NON-MODIFICATION SERVICE BULLETIN — NACELLE — HYDRAULIC  
SYSTEM — REPLACEMENT OF SUSPECT PACKING ON THE ENGINE DRIVEN  
HYDRAULIC PUMP PRESSURE SWITCH

V2500 Series 29-0267

# V2500-NAC-29-0267

LOCATION OF THE PACKING  
29-11-17 AND 29-13-17  
FIGURE 1

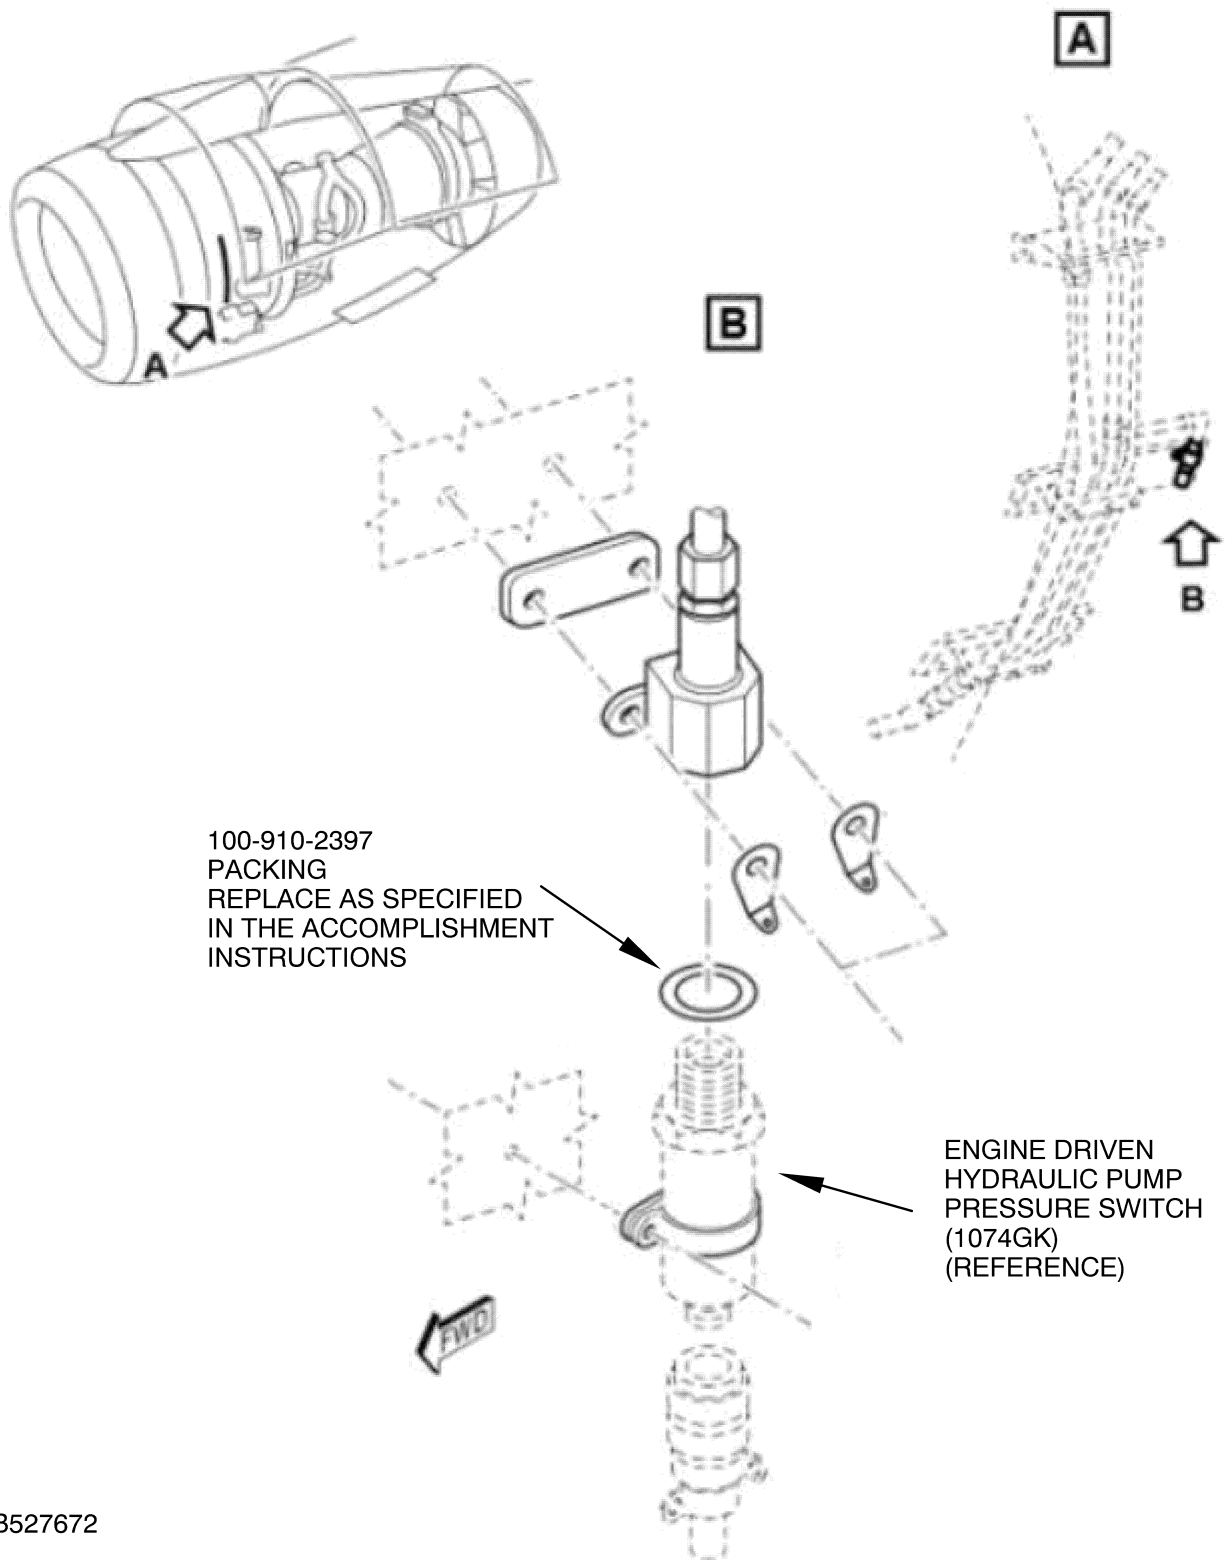
Replace the suspect packing with a new non-suspect packing.

1. Gain access to the engine as follows:
  - A. Open the fan cowl doors as specified in Reference 5, AMM Task 71-13-00-010-010.
2. Replace the engine driven hydraulic pump pressure switch packing as follows:
  - A. Remove the engine driven hydraulic pump pressure switch as specified in Reference 5, AMM Task 29-13-17-000-010 or Task 29-13-17-000-010. See Figure 1.
  - B. Remove and discard the suspect Packing, PN 100-910-2397.
  - C. Install a non-suspect Packing, PN 100-910-2397 and engine driven hydraulic pump pressure switch as specified in Reference 5, AMM Task 29-13-17-400-010 or Task 29-13-17-400-010.
3. Close access to the engine as follows:
  - A. Close the fan cowl doors as specified in Reference 5, AMM Task 71-13-00-410-010.
4. Recording Instructions
  - A. A record of accomplishment is required.
